Review of Draft Report on LOCA Frequency Estimates by Expert Elicitation

Corwin L. Atwood, Statwood Consulting
November 2, 2004

This is a review of the draft report on a task to estimate frequencies of various kinds of loss-of-coolant accidents (LOCAs) through elicitation of expert judgment and aggregation of the judgments of the experts. As requested during a two-day meeting when the report methodology was presented, the review focuses primarily on the analysis of the elicitation responses and the quantitative results. The review considers comments made at that meeting and at a meeting on Sept. 29, 2004, but it does not review the final report, which has not yet been completed. The primary conclusions of this review are the following, with item 1 being the most important.

Figure A.4. Results for Category 6 LOCAs at age 25 years, with no aggregation.

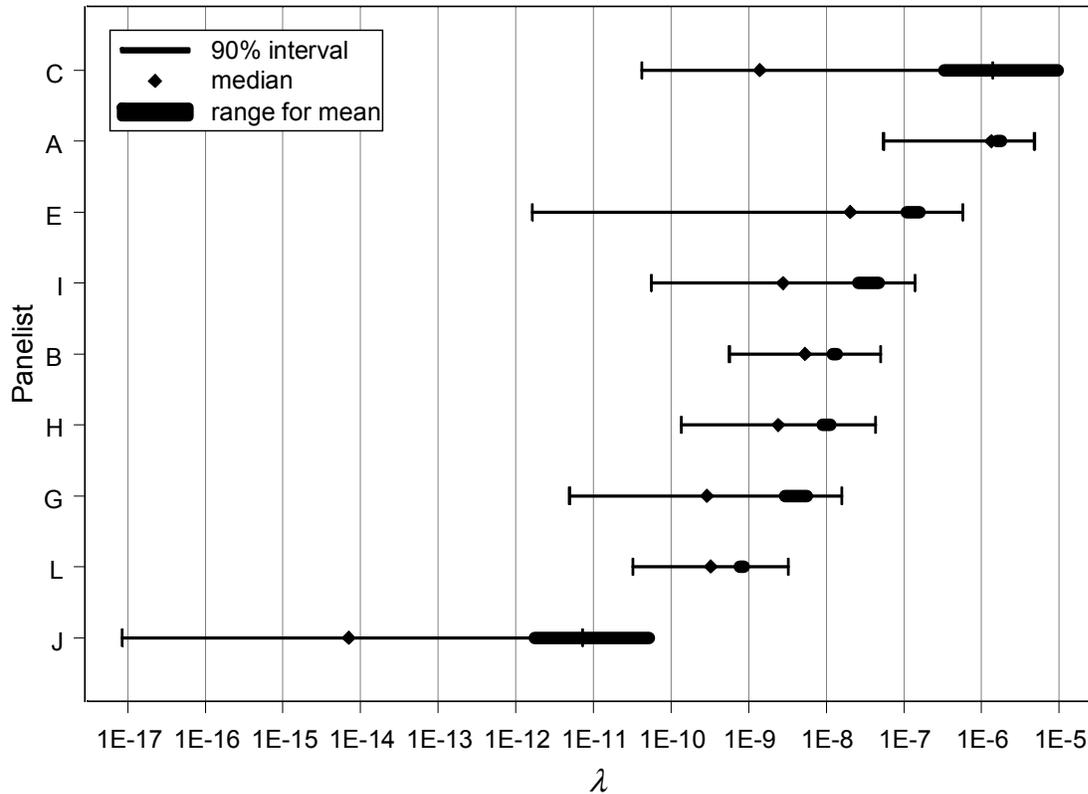
Consider now a real example, Category 6 LOCAs in PWRs of age 25 years, using the numbers from the Excel spreadsheet containing the results for this example. The intervals and medians are plotted in Figure A.4. For each panelist the possible range of the means is also shown, using

the mean of a split lognormal as an upper bound and the mean of a split log-triangular as the lower bound, as discussed in Section 3. The intervals are arranged by descending mean, where the mean is the reported value in the draft report.

It can be seen that the panelists with the longest intervals, that is, the largest error factors, have the most uncertainty in the means, as discussed in Section 3. Clearly, panelist J is an outlier at the low end. At the high end, panelist C may be considered an outlier because of the large mean and extreme skewness, or panelist A may be considered an outlier because of the large median. Identification of the outliers, especially on the right, is somewhat subjective.

Figure A.5. Results from using geometric means of percentiles to aggregate distributions, and also displaying J, A, and C individually. Data are from Figure A.4.

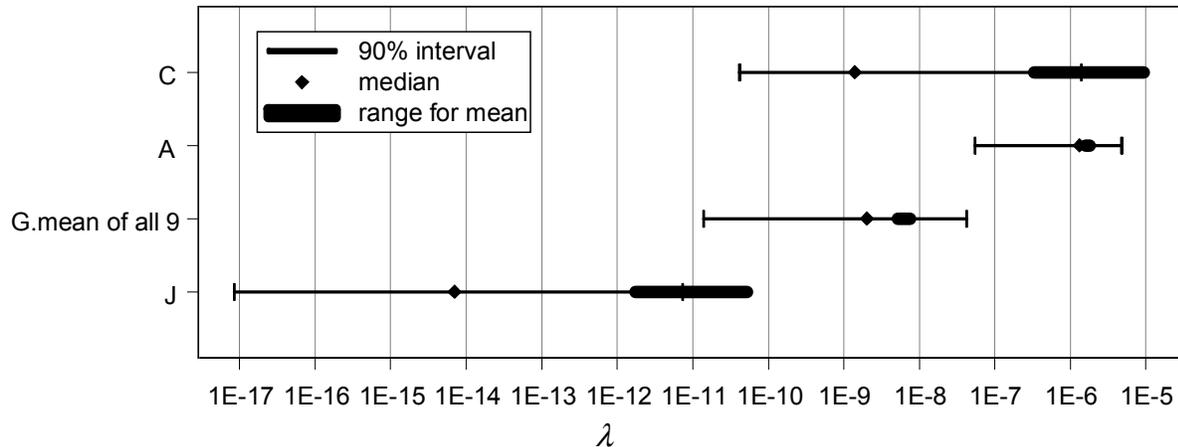
Figure A.5 shows the results of aggregating all the panelists by using geometric means of the percentiles, and showing the outliers J, A, and C separately. The bounds on the aggregated mean are calculated exactly, following the procedure given in Section 3.2.3. This figure shows that two of the outlying 90% intervals (J and A) do not overlap the aggregate 90% interval at all. Also, two outlying means are over two orders of magnitude higher than the aggregate mean, one because of a large uncertainty by panelist C and one because of an overall high estimate by panelist A. Displaying both the aggregated distribution and the outliers gives the decision makers a better understanding of the panelists' results. Incidentally, the aggregate 90% interval of the six panelists without J, A, and C is similar to the aggregate 90% interval of all nine panelists.

Figure A.6. Results from using mixtures to aggregate distributions into three groups: J, A and C, and all others. Data are from Figure A.4.

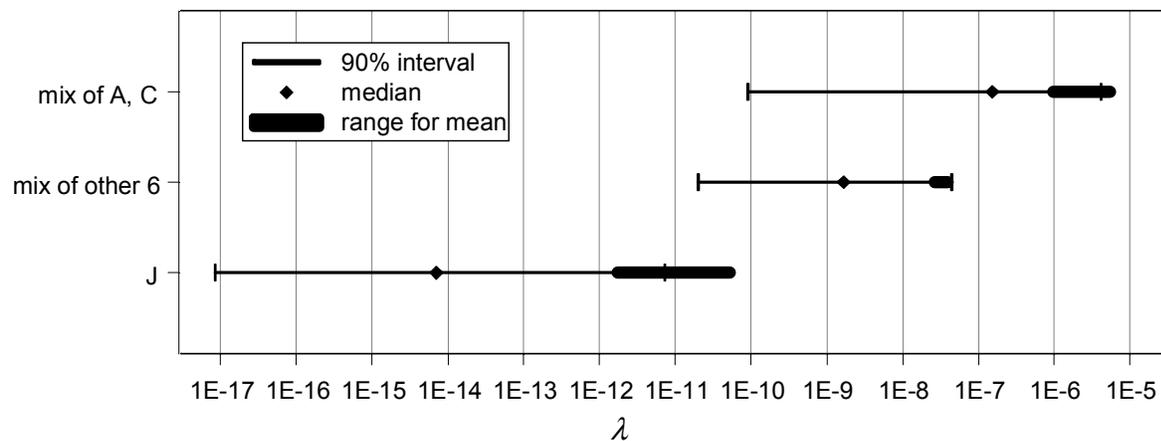
Now consider aggregation by a mixture instead of by geometric means of percentiles. Figure A.6 shows the results from using mixture aggregation if J is regarded as an outlier, A and C are regarded as an outlying pair that can be aggregated, and the remaining distributions are aggregated. Other possible identifications of outliers could be shown, but are not. Figure A.6 was calculated using Excel by constructing the c.d.f. for each panelist, and then averaging the appropriate c.d.f.s.

Observe that very similar 90% intervals are given by two different aggregations: the aggregation of all 9 distributions by geometric means of the percentiles in Figure A.5, and the aggregation of the 6 *central* distributions by a mixture in Figure A.6. However the two aggregations have means that differ from each other by half an order of magnitude.
